Reference: Docket 50-57
License R-77

**Request for Amendment
Appendix A
Technical Specifications
Buffalo Materials Research Center**

Reference: License R-77

Docket: 50-57

Current Building Ventilation Systems

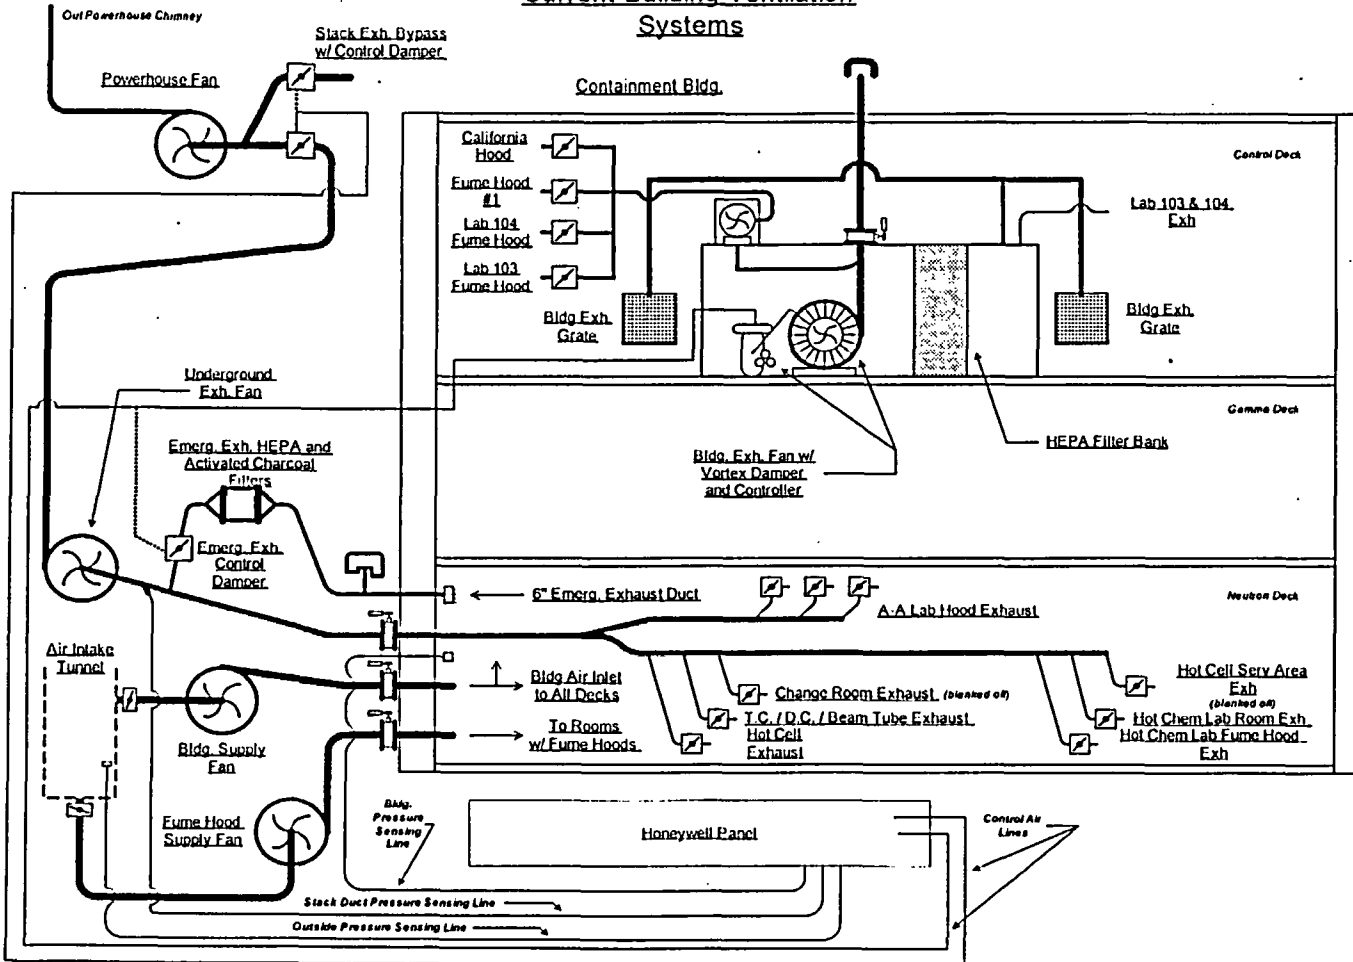
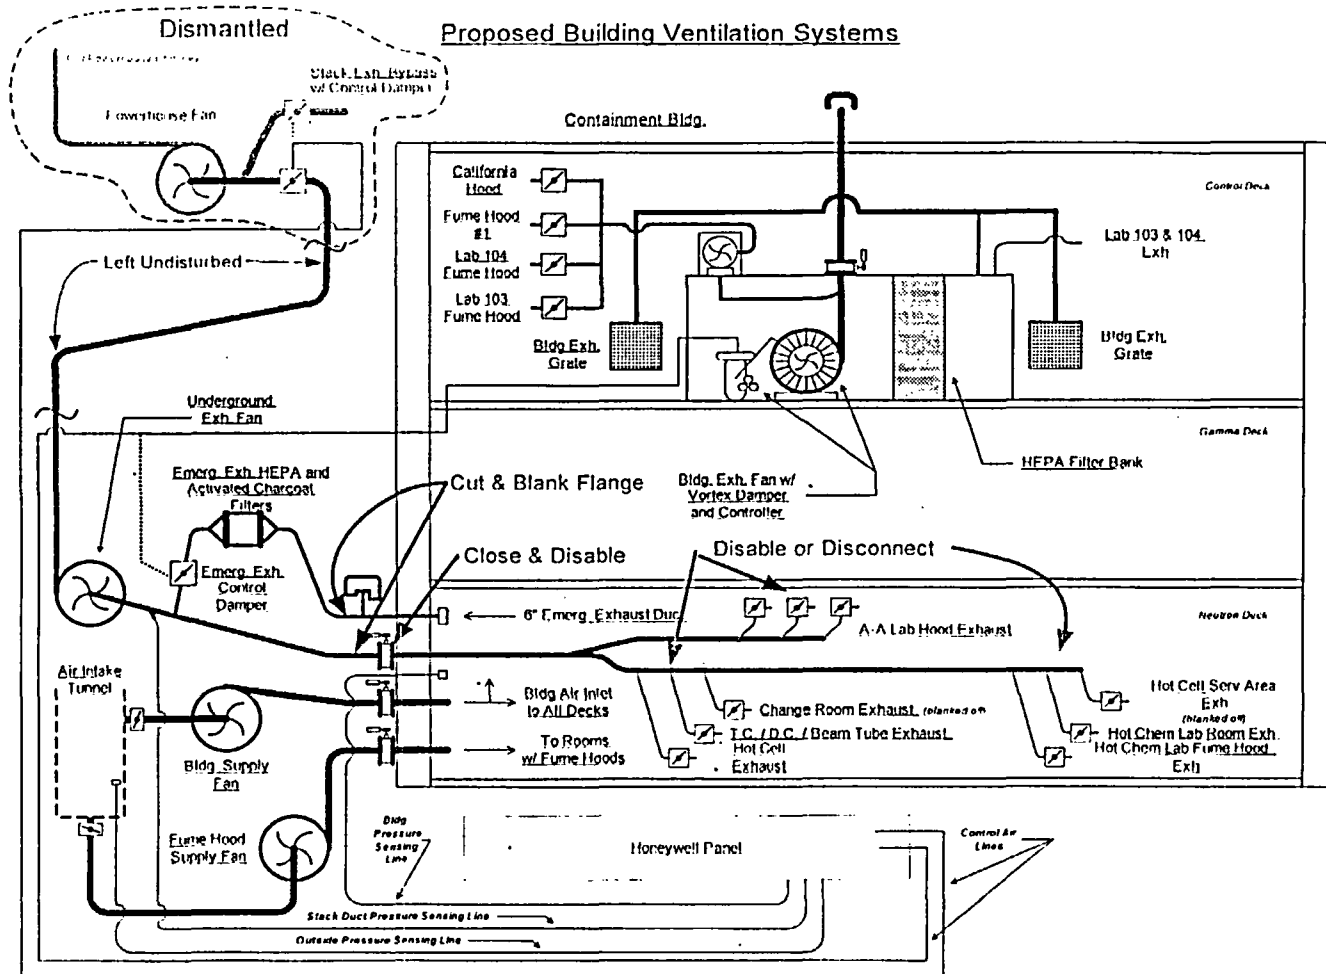
Appendix I provides schematic diagrams of the original ventilation system.

Most of the ventilation system remains operational; however the above ground segments of the stack exhaust and the fan located within the heating plant have already been dismantled.

The stack exhaust system will be eliminated. The remaining exhaust fan will be permanently removed from service. The duct will be sealed shut outboard of the Pratt damper, and the Pratt Damper will be closed. All fans that provide air to this duct will be electrically disabled or disconnected from the ducts exiting containment.

In addition the six inch emergency bypass duct will be removed from service. The duct will be sealed shut immediately outboard of the pressure relief valve.

Activity v. Time, BMRC Primary System

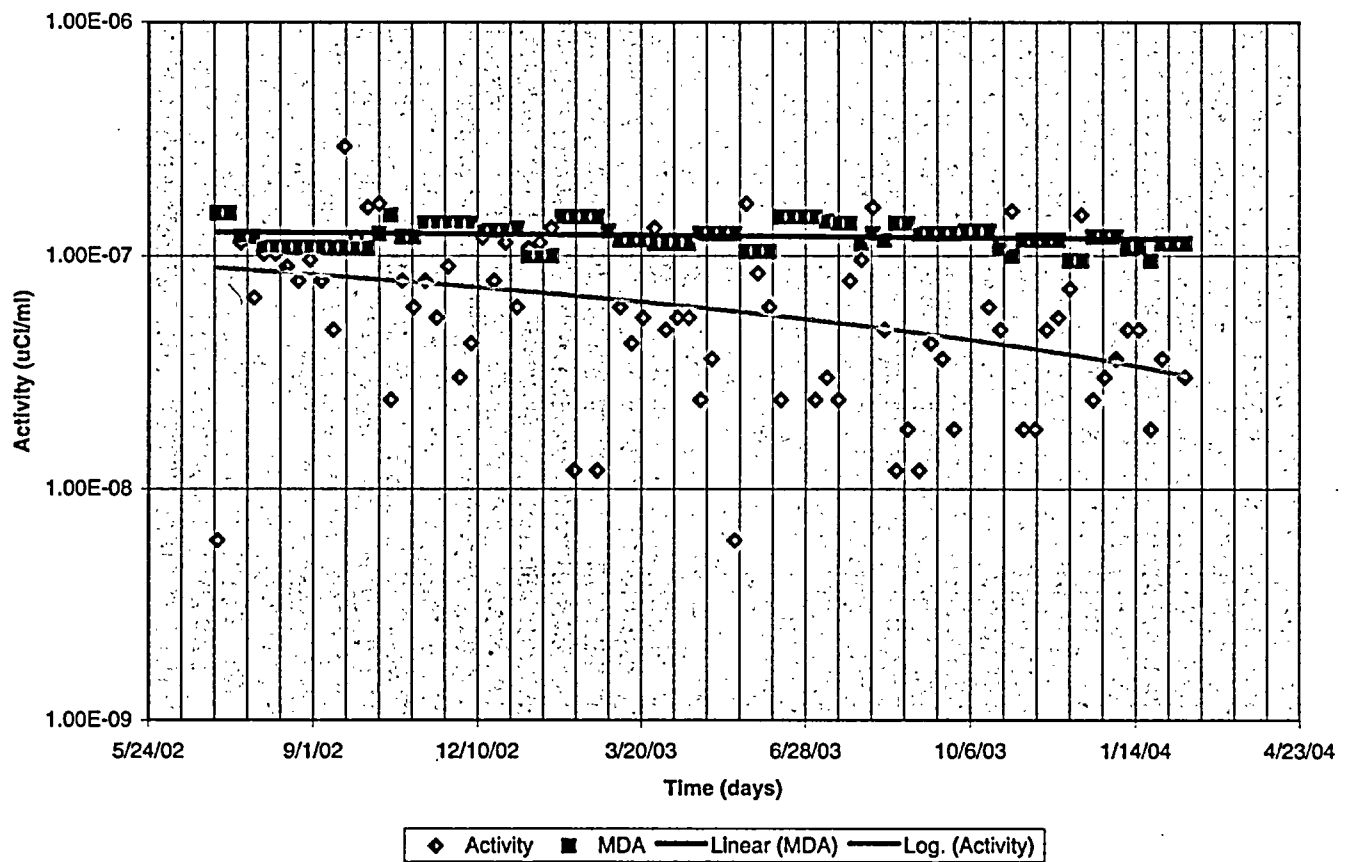
Under the proposed specifications the requirement for Gross Beta analysis of the pool water has been changed to quarterly, and the Gamma Spectroscopic requirement has been changed to semi-annual.

The reactor has now been shutdown for more than nine years. Appendix III provides a summary of the results of the gross beta and gamma spectroscopic analyses. This data demonstrates the stability of the data, and justifies performing the analyses on a less frequent basis.
